Mr. Richard Knowland, Senior Planner
February 16, 2001
Page 11

**Portland International Jetport - Phase I Parking Garage Improvements
Planning Board Application - Response to Comments**

Re: Portland International Jetport, Phase I Parking Garage
Application for Major Site Plan Approval

Gravity Storm System Layout Plan

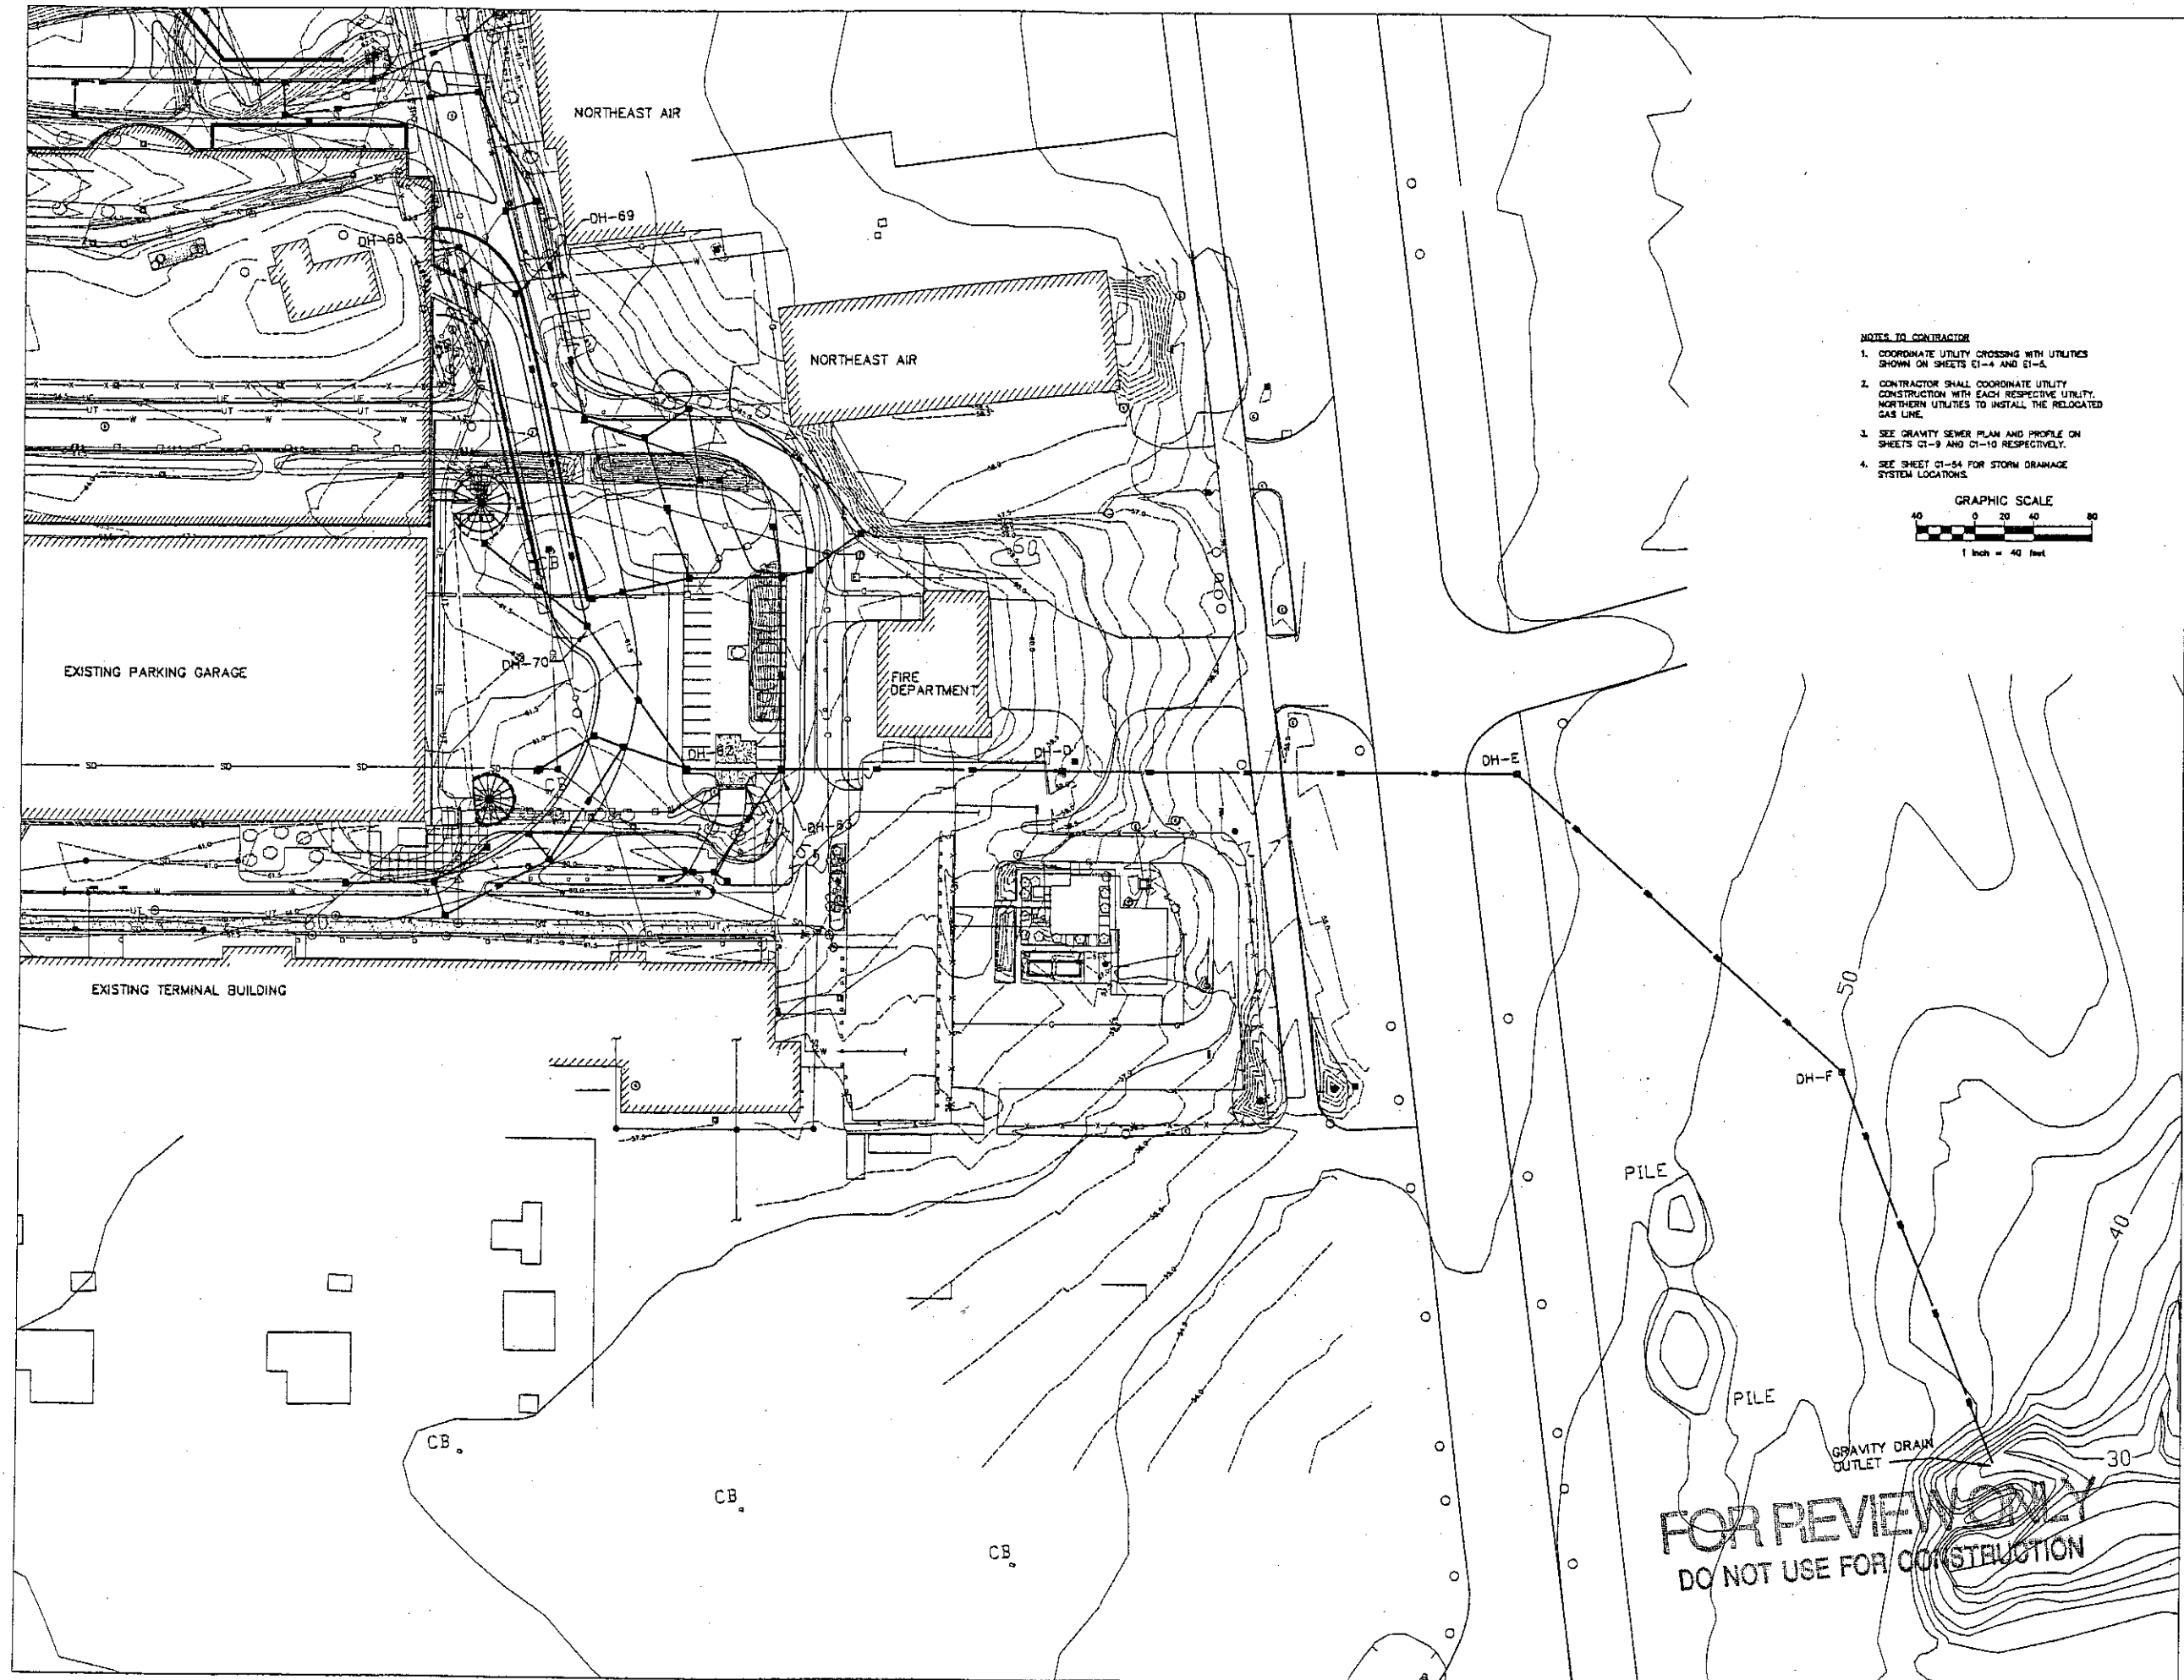
- ▶ The applicant states that an outside vendor is currently sizing the appropriate water quality treatment systems for the project. This should be discussed with the Jetport's engineers as this is a very large project and it will be necessary to apply the Planning Authority's current interpretations for water quality treatment to this project consistent with recent projects.

The "outside vendor" we were referring to in Section 14 - Stormwater Management Plan was considered to be DeLuca-Hoffman as they have designed various water quality units throughout the Jetport. A stormwater quality unit is proposed on the gravity system line prior to discharging to the natural detention basin to remove total suspended solids and oils and greases. The design of this unit was coordinated with DeLuca-Hoffman on Tuesday, February 13, 2001.

A stormwater quality unit is proposed on the gravity system line prior to discharging to the natural detention basin to remove total suspended solids. The design of this unit was coordinated with DeLuca-Hoffman on Tuesday, February 13, 2001. The stormwater quality unit design is attached and has been designed to remove 80% of the total suspended solids. Under current Maine Department of Environmental Protection guidelines, a removal credit of 50% is allowed for treatment units demonstrating that an 80% removal rate can be achieved under the design conditions discussed in the attached sizing information.

Stormwater Catch Basin Location Plan

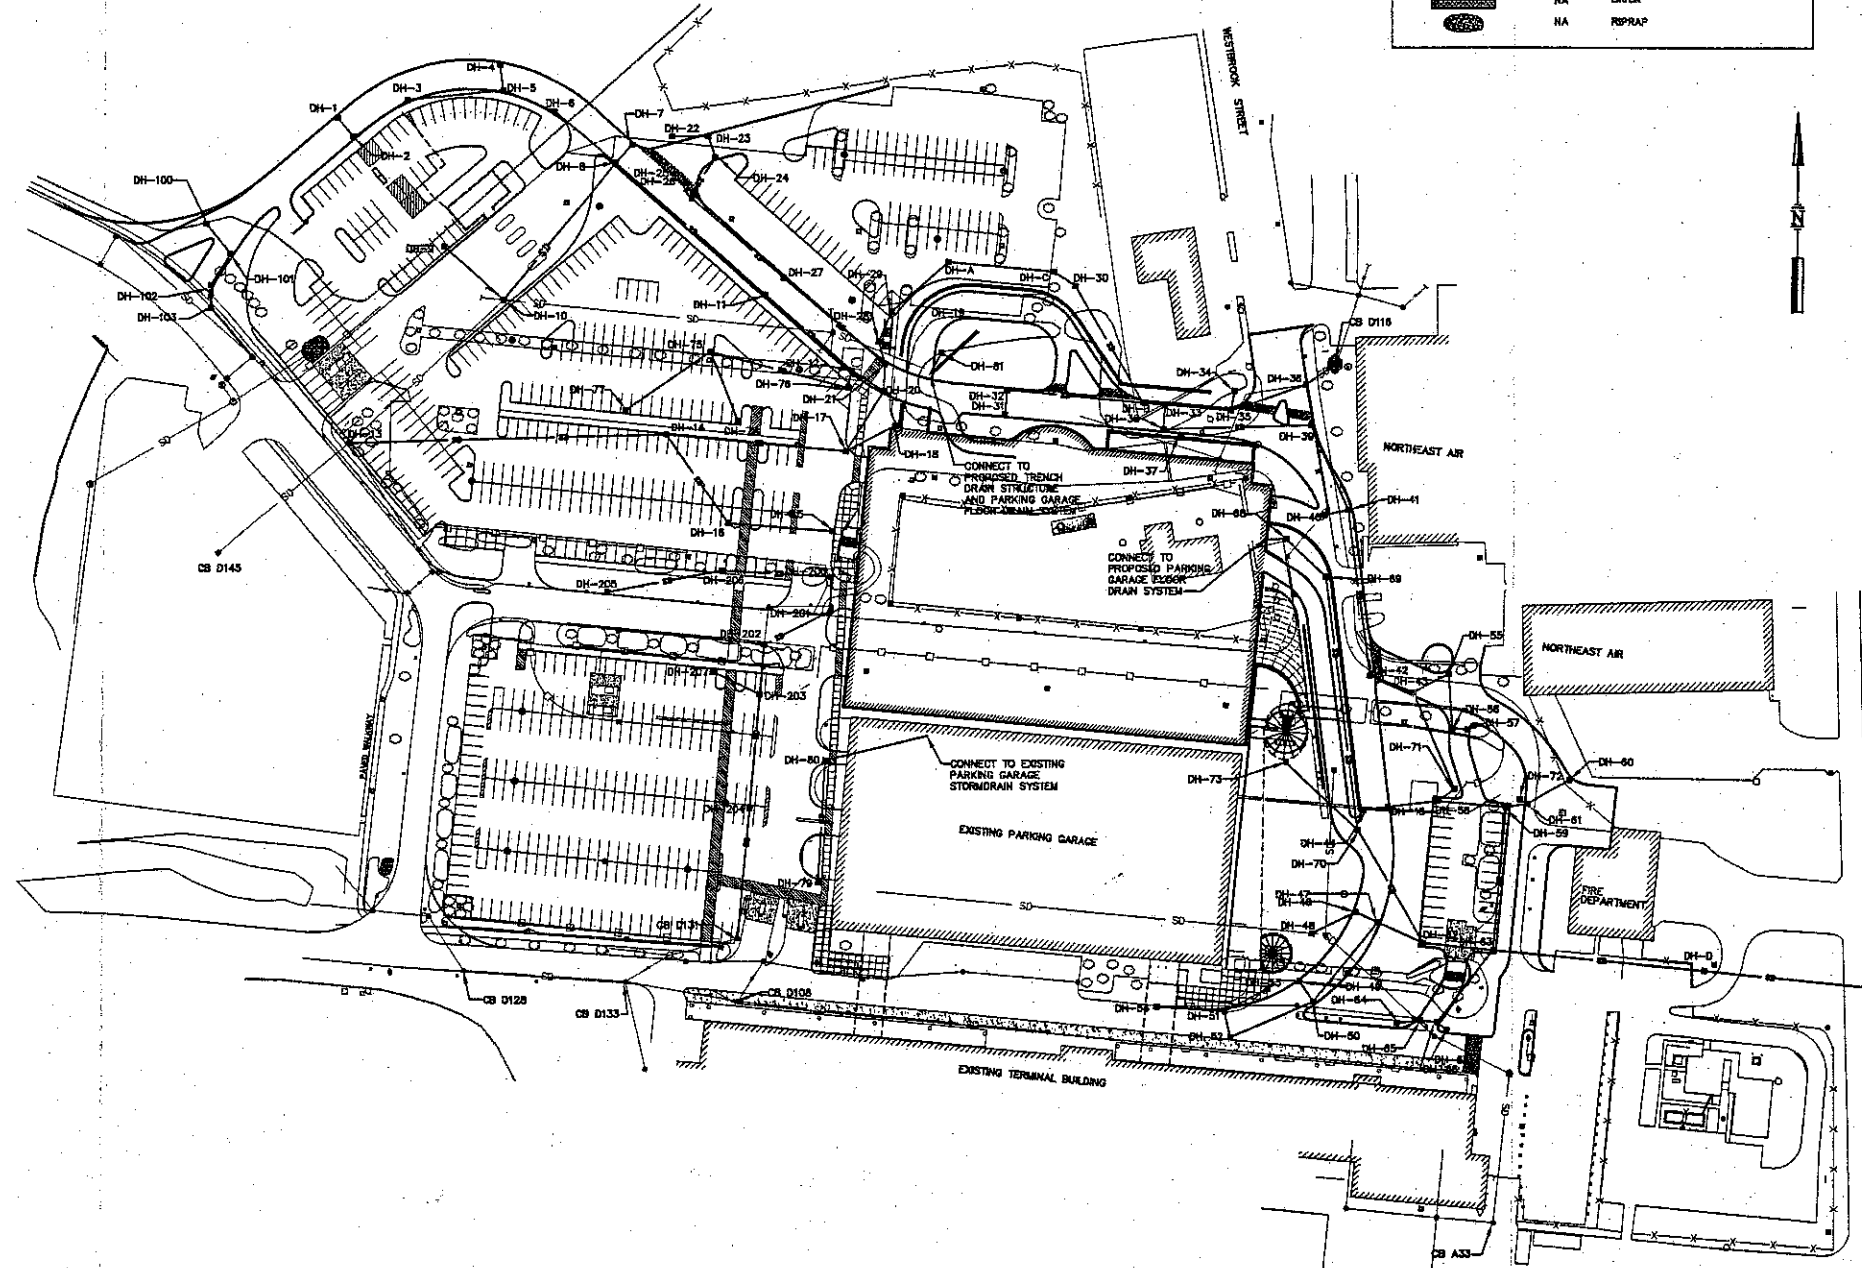
- ▶ It seems that an overabundance of catch basins are being provided along the loop road while not enough catch basins are being provided in the parking lots. The lot on the north side appears to be without a catch basin to collect runoff, particularly if the lot has curb around it.

The north parking lot has been reconfigured and the storm drain system reevaluated. This parking area will be curbed and the revised storm drain system has accounted for the curbed area.

As discussed at our February 3, 2001 meeting, we have provided additional catch basins in the surface lot west of the proposed parking garage shown on Attachment D. In addition, catch basins have been added to the surface lot west of the existing parking garage to minimize the flow of stormwater into the garage.

Parking Management Building Details

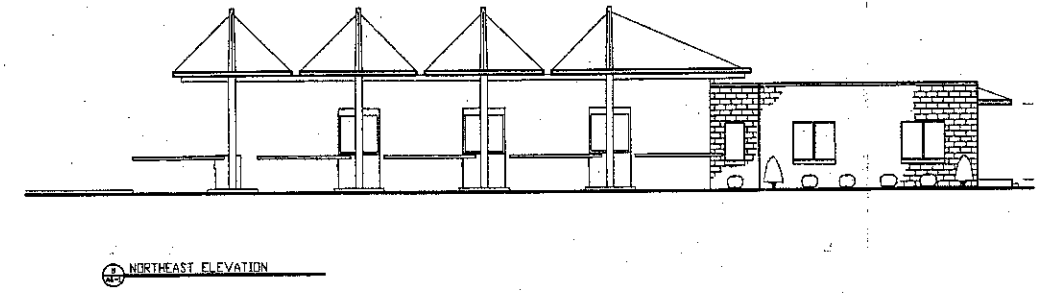
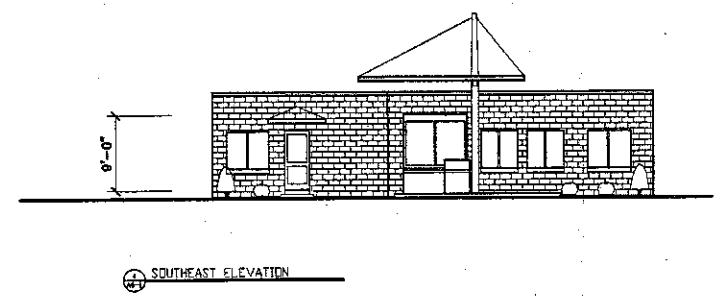
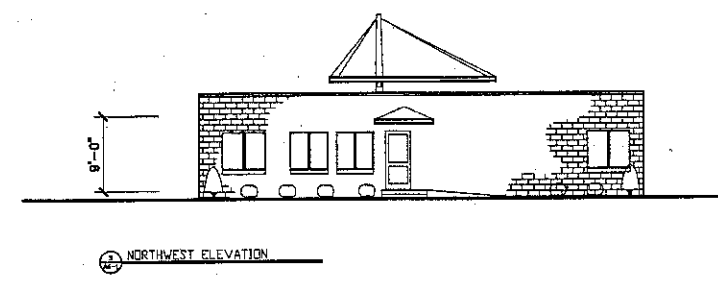
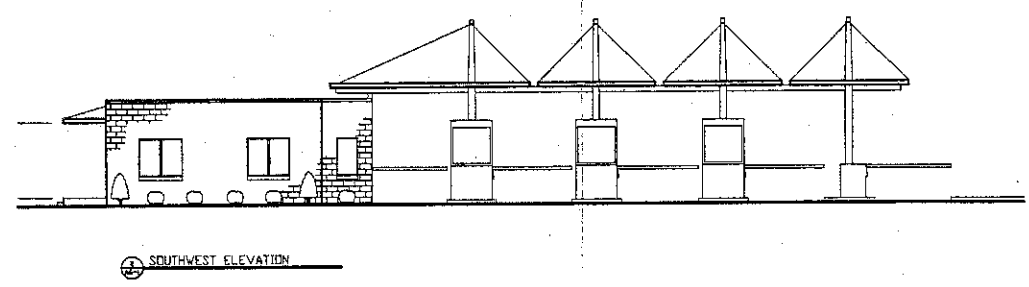
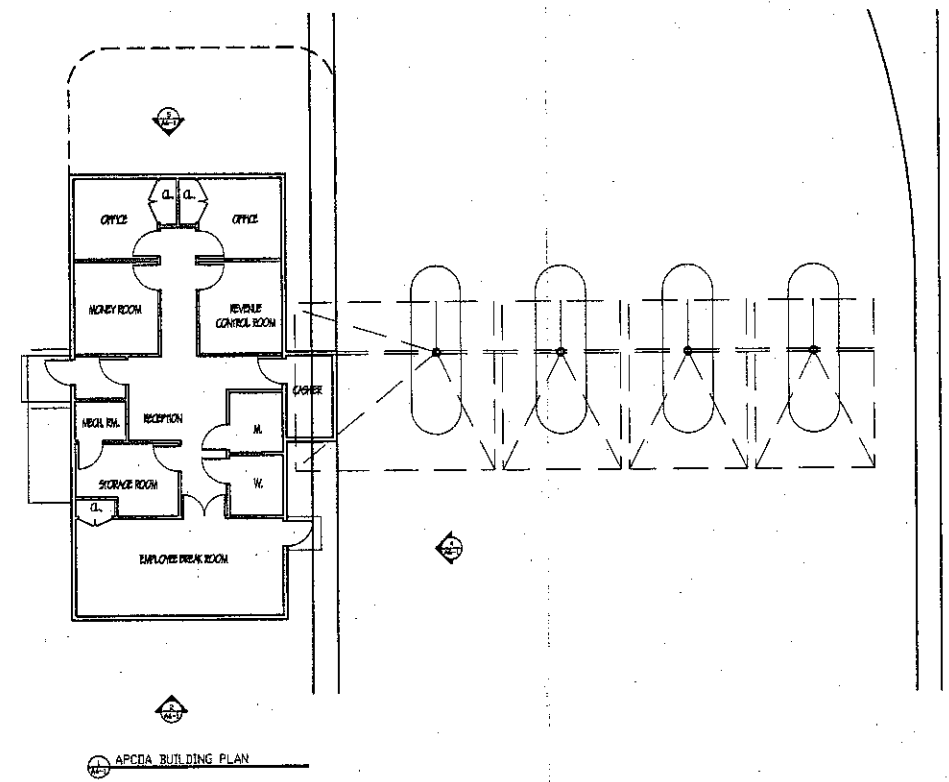
- ▶ **Provide details on the Parking Management building to be located in the new northwest surface lot.**
